SERVICE BULLETIN

- SUBJECT:** Wheel reduced life time, fatigue crack on the wheel bead seat causing loss of tire pressure.
- PURPOSE:** To identify and replace wheels used with a static load over 3400 N (748 lbs).
- MODELS AFFECTED:** 5.00-5 wheels P/N: RA-002(A), RA-002(B), RF-005(A), RF-005(B)
- S/N AFFECTED:** All
- DELAY OF APPLICATION:** Next maintenance or within 50 FH whichever comes first

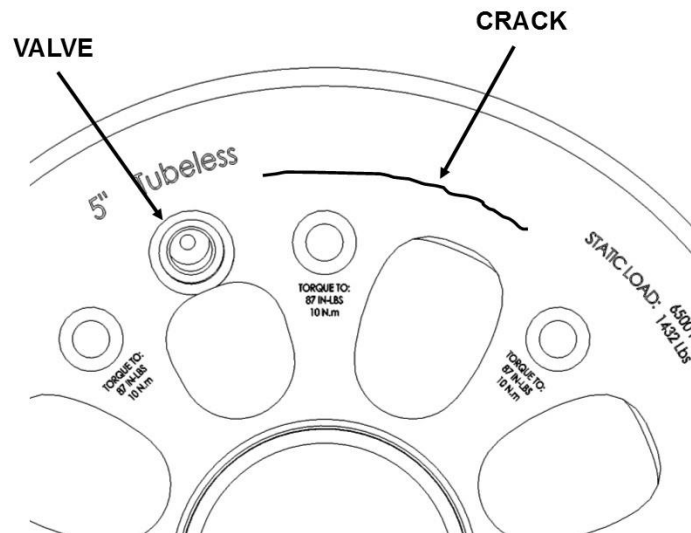
When the wheel static load is over 3400 N (748 lbs) the wheel is subjected to a reduced life time. After a certain number of rolling cycles a fatigue crack may appears in the bead seat corner of the outer wheel half (valve side). This fatigue crack causes a slow loss of tire pressure.

1. Inspect outer wheel half (valve side) and search for a visual crack near bead seat. The schema below shows the location and shape of the eventual crack. Note: the crack can be not only close to the valve but anywhere around the circumference.

2. If a crack is visible whatever the length or the position of the crack, replace the wheel by a new one.
3. If there is no visible crack the wheel can continue to be used with a limited life time reduced to 300 FH starting when the wheel was firstly installed on the aircraft. If this limit is already exceeded replace the wheel by a new one.
